This Service Information bulletin supersedes SI B51 39 11 **dated November 2012.**

Trunk Lid Intermittently Does Not Open or Latch

NEW E90 (Sedan)

NEW Produced from February 28, 2011 to June 30, 2012

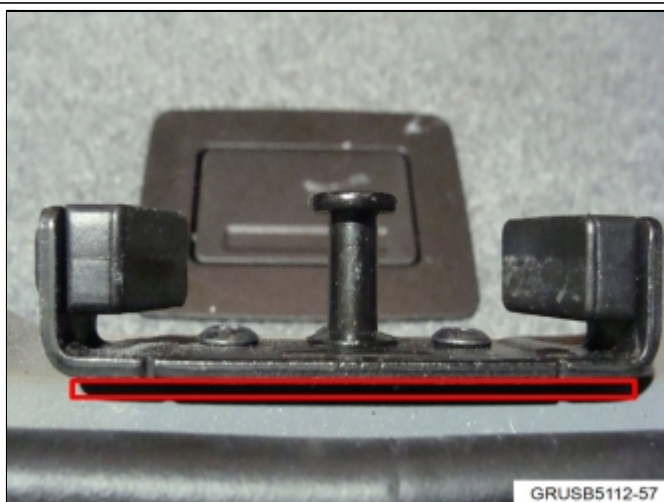
The trunk lid is out of tolerance. When opening or closing the trunk lid, the latch rubs against the striker because of insufficient clearance.

1. Inspect the trunk latch for scratch marks that indicate that the latch is engaging the striker improperly.
2. Replace the latch if scratch marks are found as per ISTA Repair Instructions "51 24 100 Removing and installing/replacing rear lid lock (upper section)."

3. Replace the striker as per ISTA Repair Instructions "51 24 130 Removing and installing/replacing striker for rear lid lock."
4. Install a spacer plate (P/N 51 24 7 348 321) between the striker and the body before installing the new striker.
5. Check the trunk lid operation by opening and closing the trunk 10 times, using the remote key and inside vehicle trunk release

button. Ensure that the latch does not contact the top of the striker and new scratch marks do not appear on the latch.

6. Install a second spacer plate if the latch still contacts the top of the striker. Retest the system 10 times again.
